Transmitter Spec. with Tx_DP (Comments #432, 433, 434, 435)

Comments and Suggested Remedy for 802.3dj D2.2

3 Types of CDP Comparisons

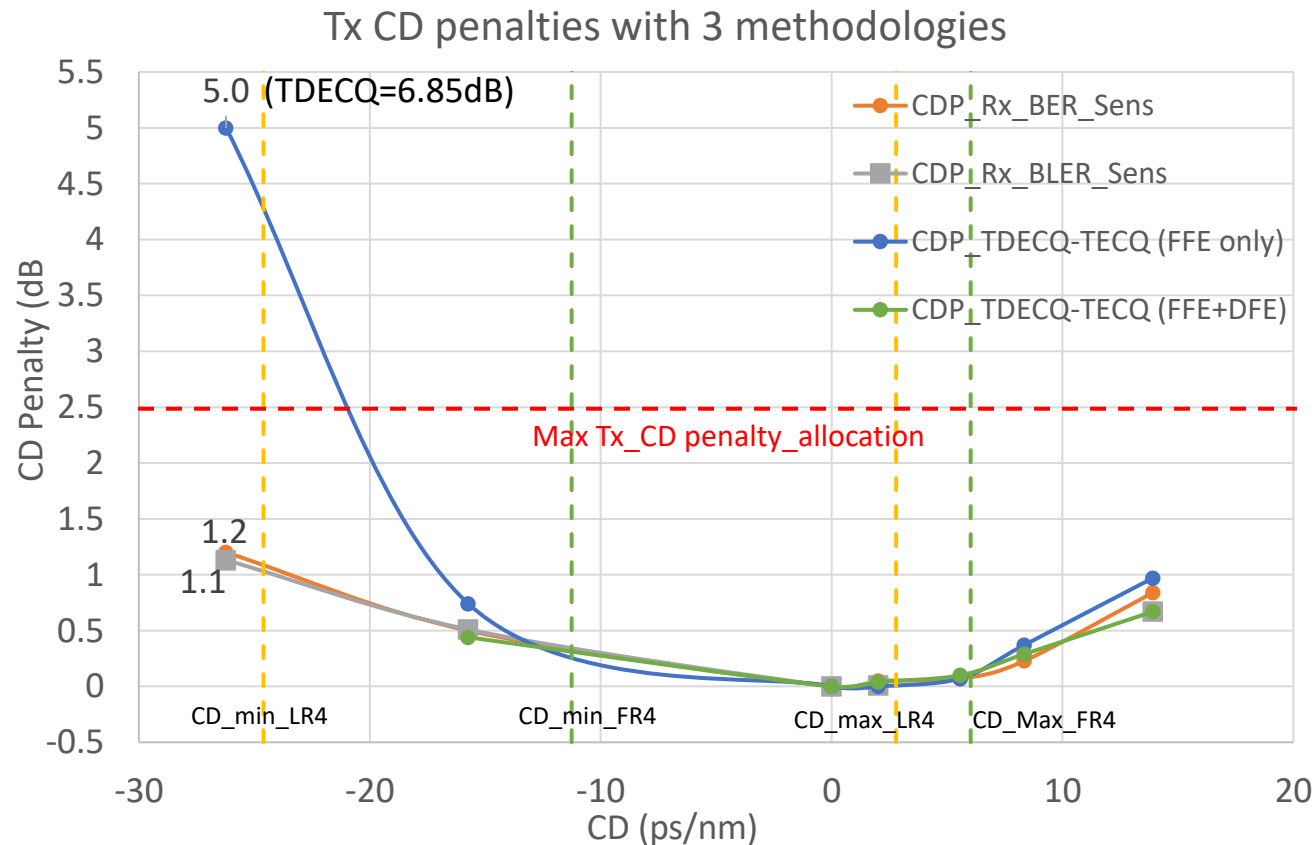
- DUT: A Sipro MZM based 200G/L FR4 TRx module with the DSP from vendor A
- Measurement points collected at different dispersion values by setting up proper fiber-wavelength combinations
- Much higher penalties with CDP_TDECQ-TECQ vs. CDP_Rx_BER_Sens and CDP_Rx_BLER_Sens

CDP for SiPho MZM and InP EML Based Transceiver Samples

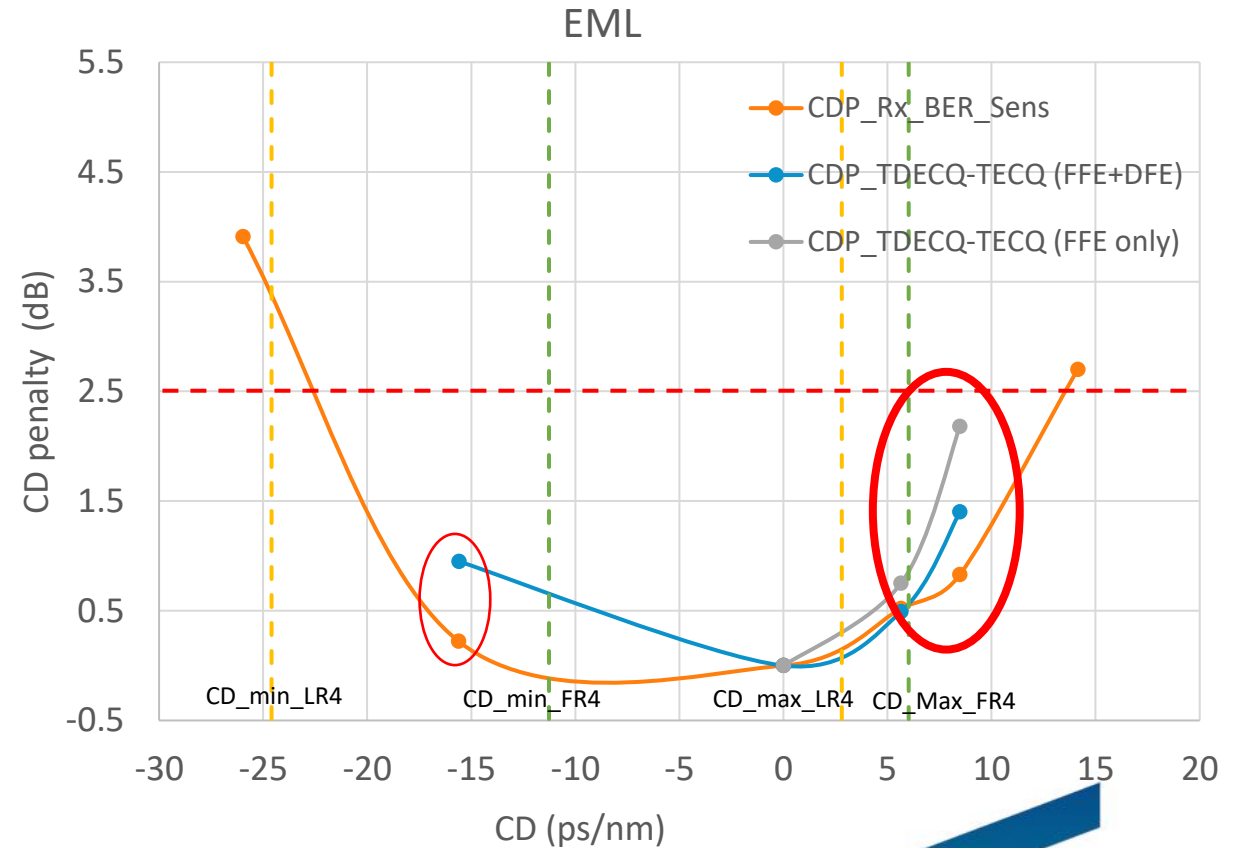
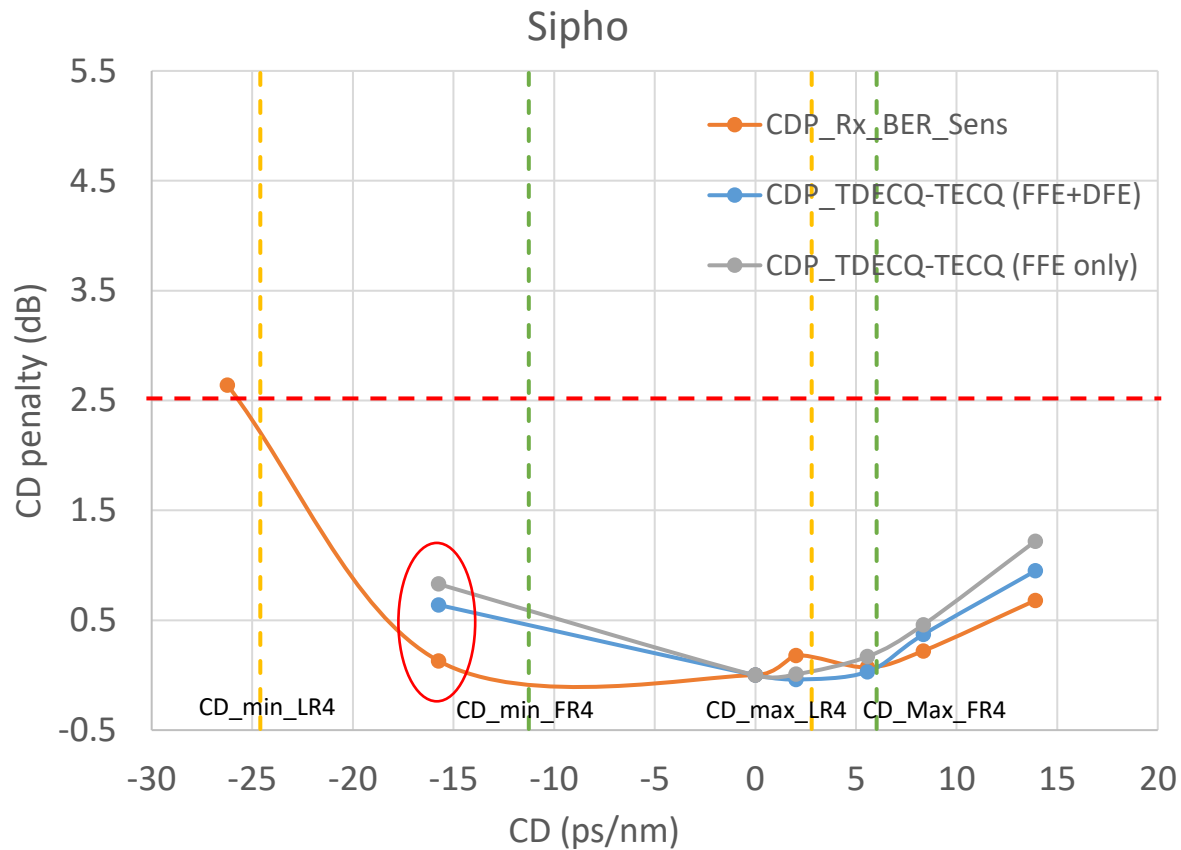
- DUTs: SiPho MZM and InP EML based 200G/L FR4 modules
- Both DUTs are with DSPs from vendor B to keep Rx with similar performance
- SiPho Tx showed more stable operations over the full range of dispersion at lower CDP
- EML sample: CDP_TDECQ-TECQ much higher vs. CDP_Rx_BER_Sens near CD_Max_FR4
